Access Compliance Report

Public Rights-of-Way

(Curb Ramps)

Intersection ID: 46310	Main Street: BRIDLE_BROOK_WY	Cross Street: BECKET_RIDGE_RD	Location: SW
ADA ID: 224DA11CB80D	Ramp Type: PerpDiag	Initial Pass/Fail: Fail	Overall Compliance: No
		Severity Score: 10

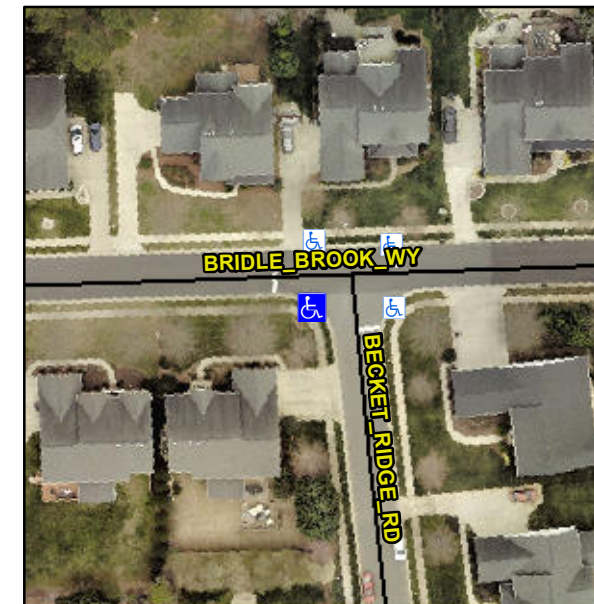
Not Found, R304.5.1, R304.5.3

Compliance	Description	Data	Compliance	Description	Data
N/A	Ramp Length (in)	49.5	Yes	Ramp Slope (%)	6.9
No	Ramp Width (in)	45.0	No	Ramp XSlope (%)	3.5
N/A	Flare Type LT	N/A	N/A	Flare Type RT	N/A
N/A	Flare Slope LT (%)	N/A	N/A	Flare Slope RT (%)	N/A
N/A	Flare Traversable LT?	N/A	N/A	Flare Traversable RT?	N/A
N/A	Landing Length (in)	N/A	N/A	DWS Provided?	N/A
N/A	Landing Width (in)	N/A	N/A	DWS Contrast?	N/A
N/A	Landing Slope (%)	N/A	N/A	DWS Length (in)	N/A
N/A	Landing X Slope (%)	N/A	N/A	DWS Full Width?	N/A
N/A	Landing Curb? (Y/N)	N/A	N/A	DWS Offset (in)	N/A
N/A	Shared Landing?	N/A			
N/A	Gutter Ponding?	N/A	N/A	Gutter Slope (%)	N/A
N/A	Gutter Lip Ht (in)	N/A	N/A	Gutter X Slope (%)	N/A
N/A	Painted X Walk1?	No	N/A	Painted X Walk2?	No
	X Walk 1 Direction	To E		X Walk 2 Direction	To N
N/A	X Walk 1 Width (in)	N/A	N/A	X Walk 2 Width (in)	N/A
	X Walk 1 Slope (%)	2.2		X Walk 2 Slope (%)	2.8
	X Walk 1 X Slope (%)	3.0		X Walk 2 X Slope (%)	0.4

Remove & Replace Curb Ramp With Two New Directional Ramps or Equivalent.
